SUBJECT: SUMMARY OF DECEMBER 16, 1999, MEETING WITH BNFL
 FUEL SOLUTIONS AND CONSUMERS ENERGY

Docket No. 72-1026

Talking Points for Clarification on Cladding Temperature Limit and High Burnup Fuel Analyses

Comparison of Spilker Time Exponent with FRG-2 Unirradiated and Irradiated Creep Strain Data

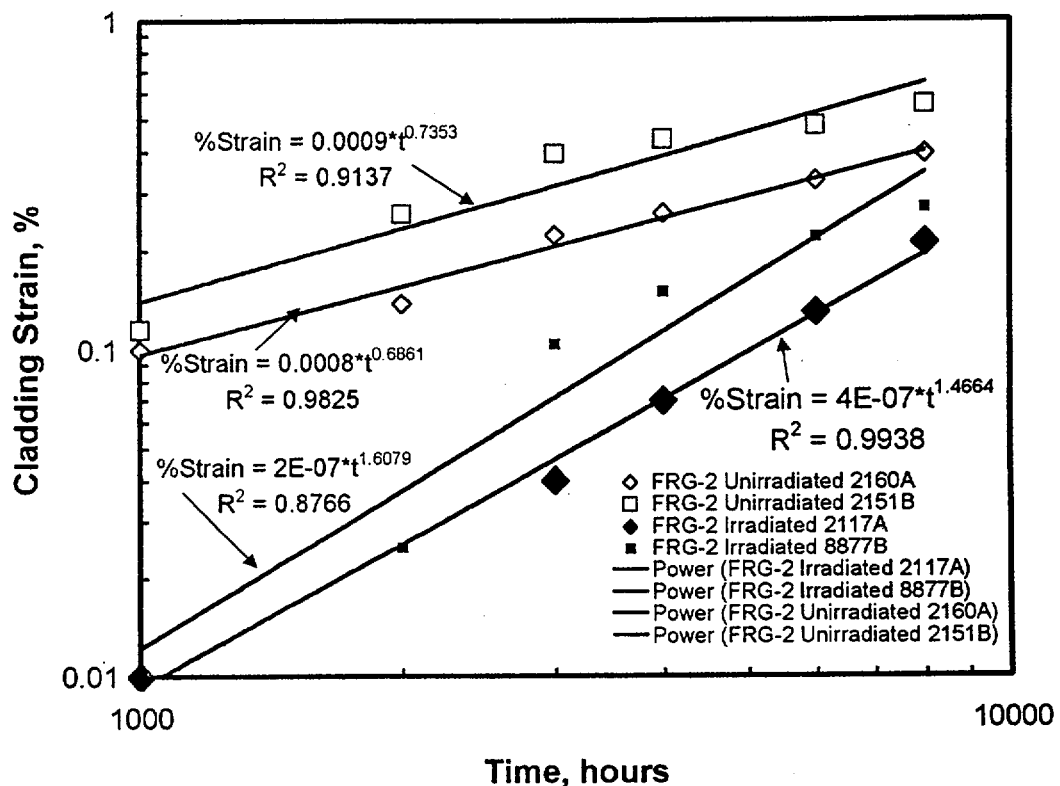
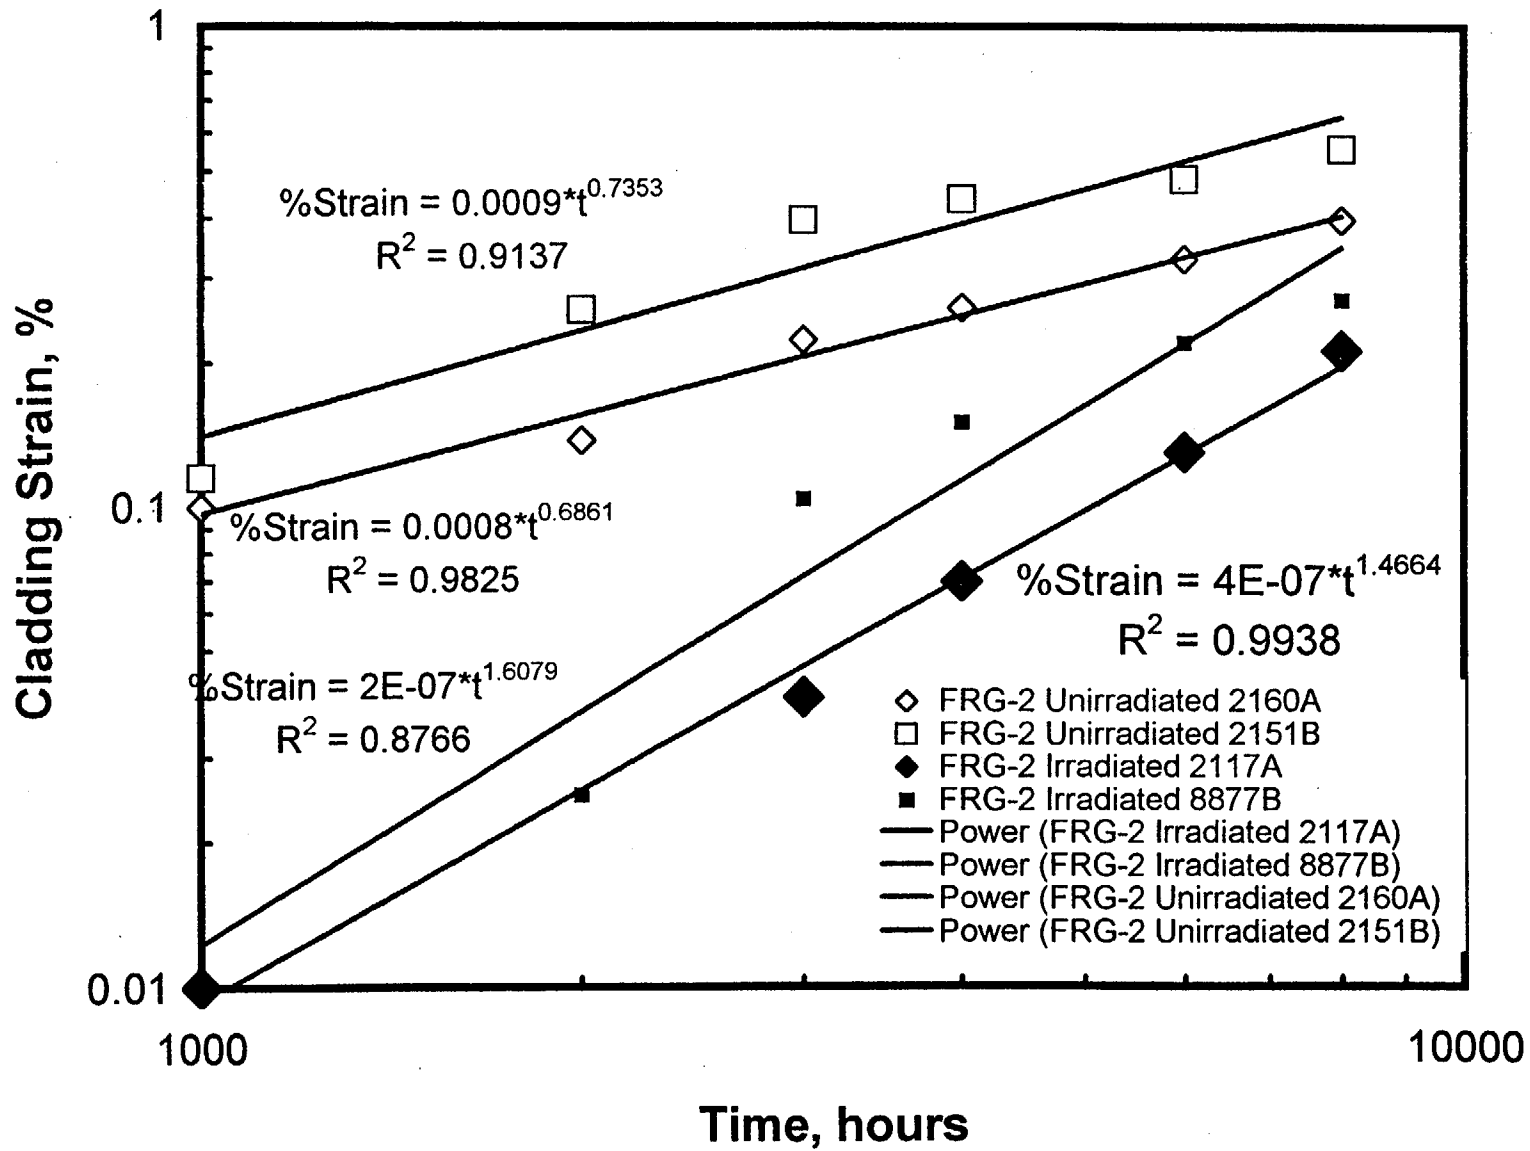
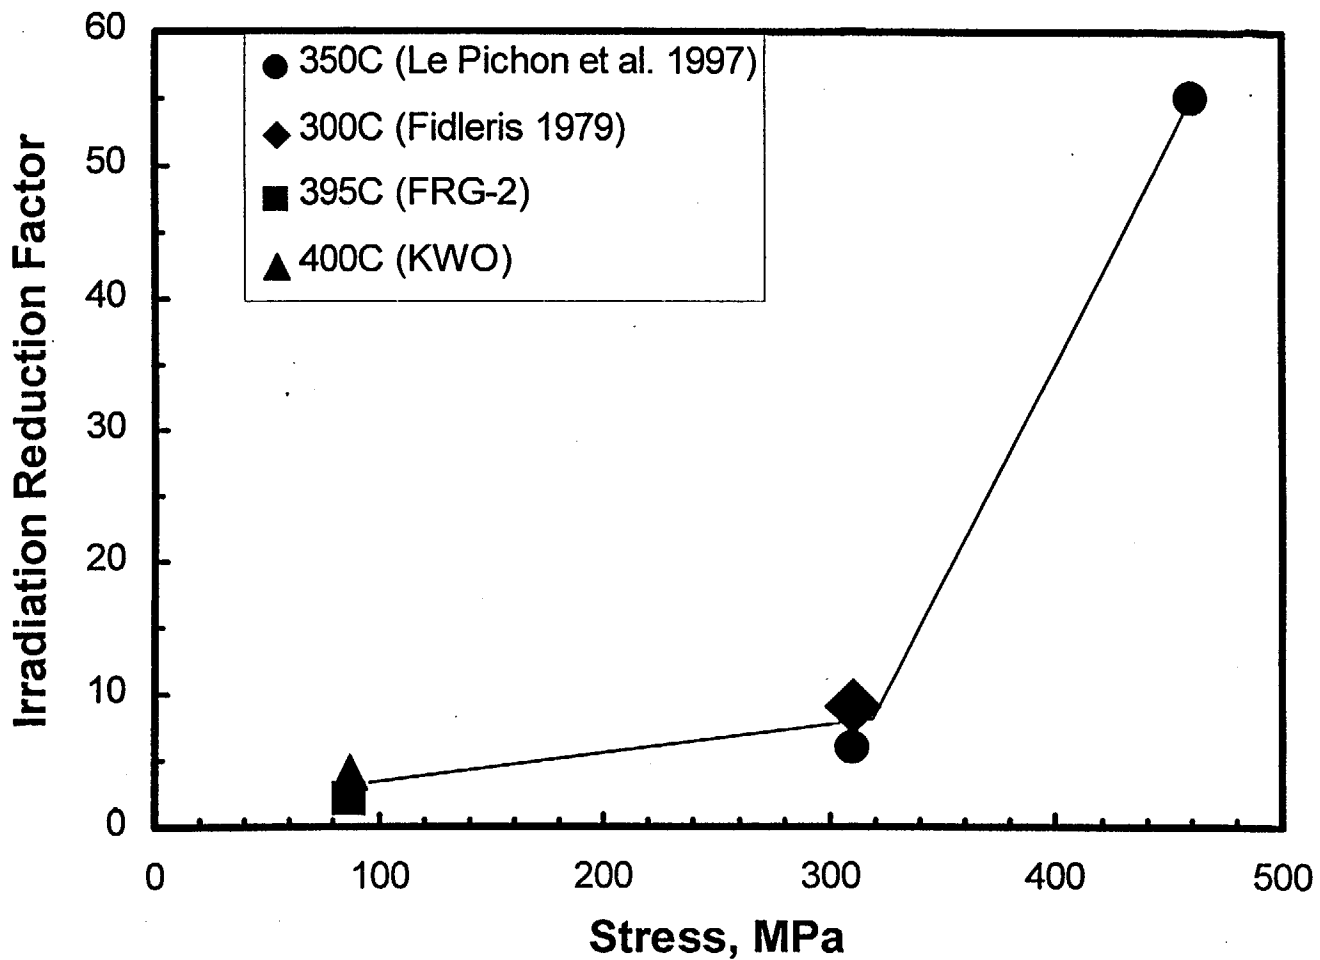
4. The factor of 10 between the Spilker equation for unirradiated Zry-4 and the irradiated FRG-2 creep data does not appear to be defensible. The difference between the unirradiated FRG-2 (WCAP-15168, Figure 4-2) and the irradiated (WCAP-15168, Figure 4-4) creep data are shown to range from a factor of 1.4 to a factor of 2.5 for a stress of ~87 MPa and 395°C. Examination of other published data show the ratio of unirradiated to irradiated creep to be strongly stress dependent. The values of the creep reduction factor (of unirradiated to irradiated creep) in the Schaeffler-LePichon et al. 1997 work decrease from ~55 at 460 MPa to ~6 at 310 MPa at 350°C. Further, the value at 300°C and 310 MPa is ~9 (Fidleris 1979 ASTM STP 681).
